**Preliminary Site Plan/PUD Review  
For  
City of Northville, Michigan**

<b>Applicant:</b>	Hunter Pasteur Northville LLC 32300 Northwestern Highway, Suite 230 Farmington Hills, MI 48334
<b>Project Name:</b>	The Downs Planned Unit Development (PUD)
<b>Plan Date:</b>	December 15, 2021
<b>Location:</b>	Vacant parcels on the south side of Cady St. (between S. Center and Griswold), the Northville Downs racetrack property south of Cady St. (between S. Center St. and River St.), and two areas on the west side of S. Center St.
<b>Zoning:</b>	CBD – Central Business District CSO – Cady Street Overlay District RTD – Racetrack District R-2 – Second Density Residential District
<b>Action Requested:</b>	Preliminary Site Plan/PUD Review
<b>Required Information:</b>	As noted within this review

### **Row Houses**

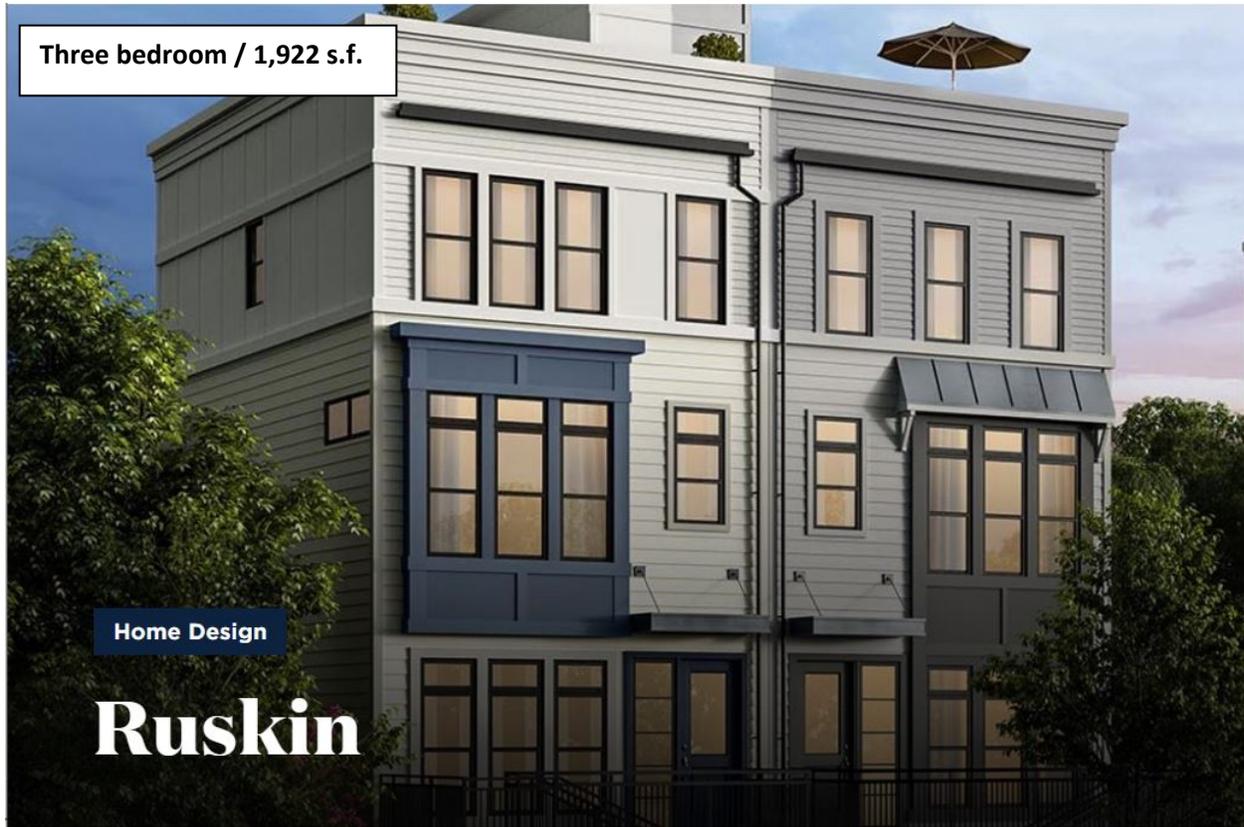
Elevations and floor plans of the proposed row houses have also been provided. We agree with the different architecture between the buildings that face Cady St. (more urban character), and the buildings that face the more residential Griswold St. The plans have been amended to replace townhomes with row houses at the north sides of Beal, at the intersections of Griswold and S. Center St. Which building style will be placed in these locations? These buildings are also located in the Historic District (along Cady & Griswold), and will require HDC approval.
